**POCATELLO CITY COUNCIL
MEETING HELD THURSDAY JUNE 5, 2025
EXECUTIVE SUMMARY**

The request is for Final plat approval of a subdivision to be known as Hospital View Division 1. The proposal calls for the platting of 3.669 acres (more or less) of the 13.13-acre parent parcel (RPRPCPP086110) into four (4) commercial lots and two (2) common lots. This portion of the 13.13-acres is zoned Residential-Commercial-Professional (RCP). Municipal Code does not require that a minimum lot size be maintained. Land uses are outlined under Municipal Code Section 17.03.500 (Use Table). The application was submitted by Bryce Marsh on behalf of property owner JG Ventures LLC.

To: Matthew Lewis, Senior Planner

PRELIMINARY PLAT
FOR
HOSPITAL VIEW

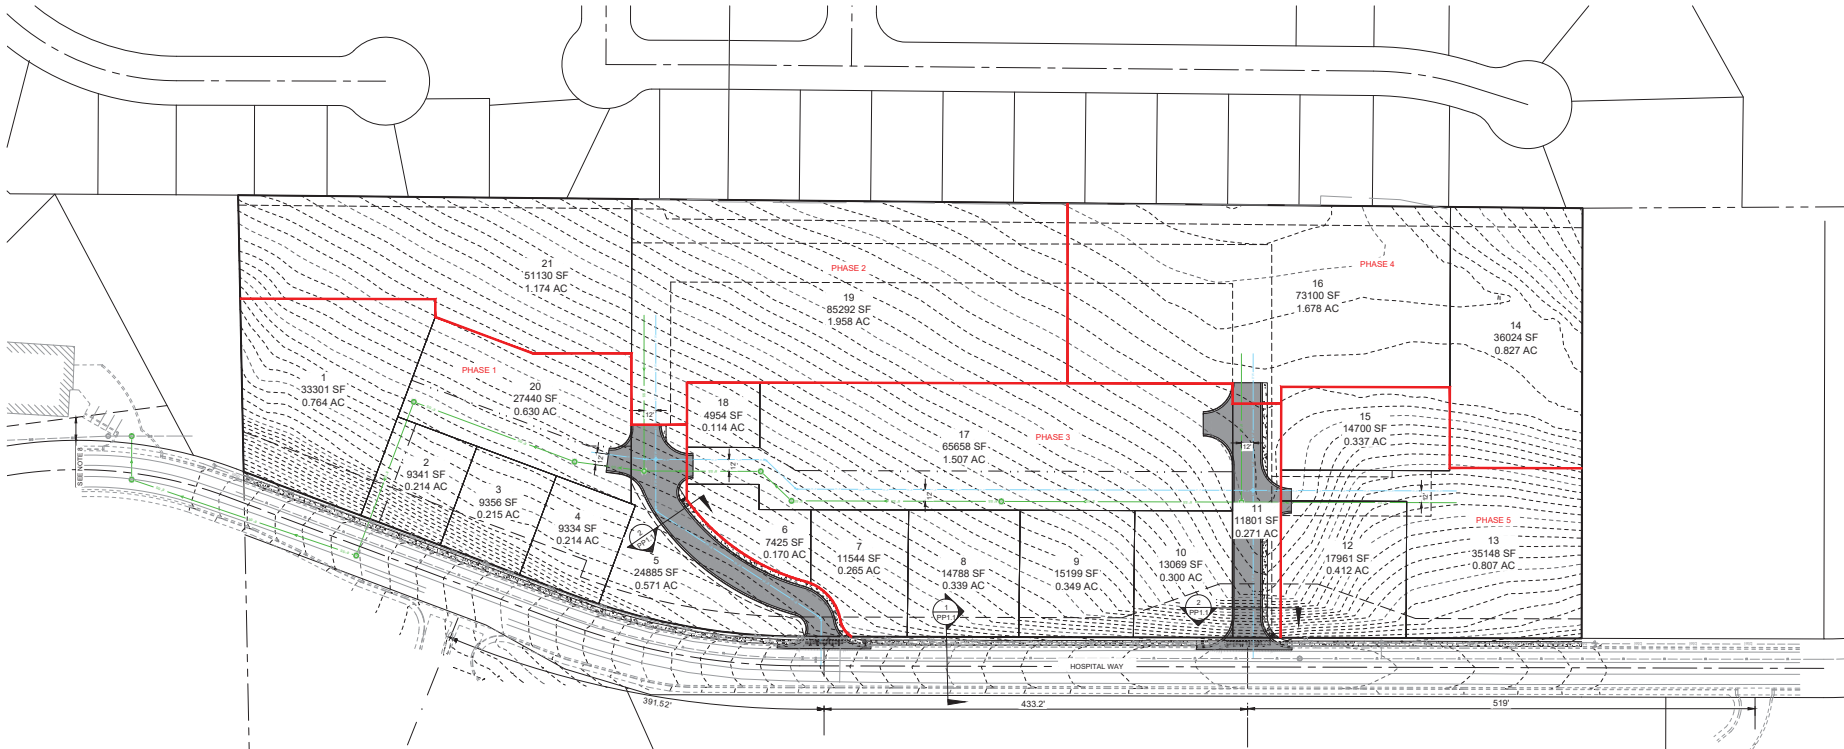
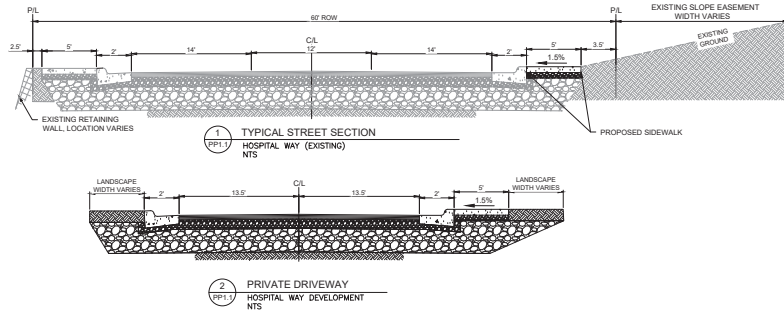
3. Provide a site distance evaluation and cross sections for approaches connecting to Hospital Way.
4. Roads connecting to Hospital way shall have a 150 feet tangent length from Hospital Way east right of way line or a minimum curve radius of 400 feet with a 60-foot tangent to Hospital Way east right of way line.

9. Provide dumpster locations and access agreement language on Plat for sanitation vehicles.
10. Main line taps to be done by City of Pocatello Water Department at developers expense.

18. All sewer & water in development shall be private.
19. Access to all manholes in development for maintenance purposes shall be maintained.
20. Show location & details of stormwater infrastructure.
